PRODUCT CHANGE NOTIFICATION

Bourns® EMS Non-Contacting Absolute Encoder Connector Change

Model EMS22A and EMS22Q Series

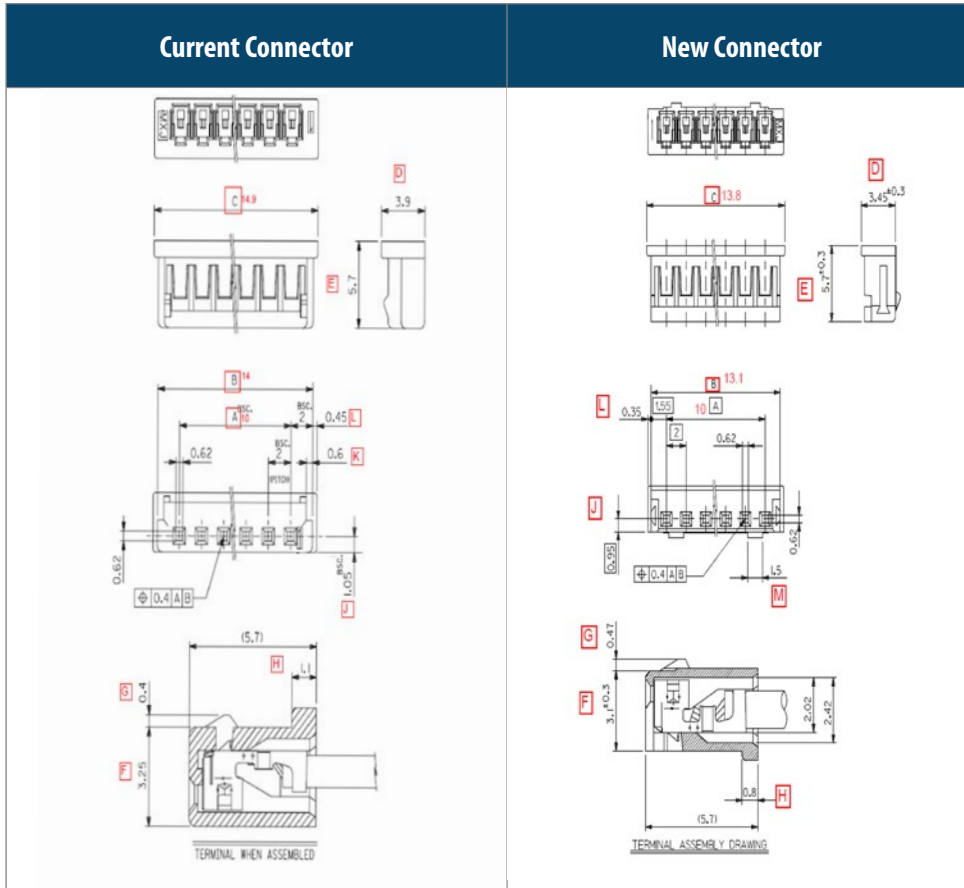
Riverside, California – May 26, 2020 – Effective **immediately September 1, 2020**, the connector used for the Bourns® Model [EMS22A](#) and [EMS22Q](#) series will be changed to the Molex 051065-0600. The current connector has been discontinued by the manufacturer. The dimensions of the Molex 051065-0600 are slightly different than the original connector but the replacement connector is made with comparable materials. The change in dimensions shown on the following page could impact the customer's application. Affected part numbers are listed below.

The change in dimensions will affect the form and fit of the product. This change will have no effect on the function, quality or reliability. Samples for evaluation are available upon request.

Description	Current P/N: 051090-0600	Replacement P/N: 051065-0600	Replacement meets spec
Agency Certification			
CSA	LR19980	LR19980	✓
UL	E29179	E29179	✓
Physical Specification			
Color - Resin	Natural	Natural	✓
Flammability	94V-0	94V-0	✓
Gender	Receptacle	Receptacle	✓
Glw-Wire Capable	No	No	✓
Material - Resin	Polyester	Polyester	✓
Net Weight	197.000/mg	159.700/mg	✓
Number of Rows	1	1	✓
Pitch - Mating Interface	2.00mm	2.00mm	✓
Temperature Range - Operating	-40° to +105°C	-40° to +105°C	✓
Dimensional			
DIM A	10	10	✓
DIM B	14	13.1	X
DIM C	14.9	13.8	X
DIM D	3.9	3.45 ± 0.3	X
DIME	5.7	5.7	✓
DIM F	3.25	3.1	X
DIM G	0.4	0.47	X
DIM H	1.1	0.8	X
DIM J	1.05	0.95	X
DIM K	0.6	missing	X
DIM L	0.45	0.35	X
DIM M	missing	1.5	X

Note: For this replacement the mating connector must be changed to manufacturer series P/N: 53253 or P/N: 53254
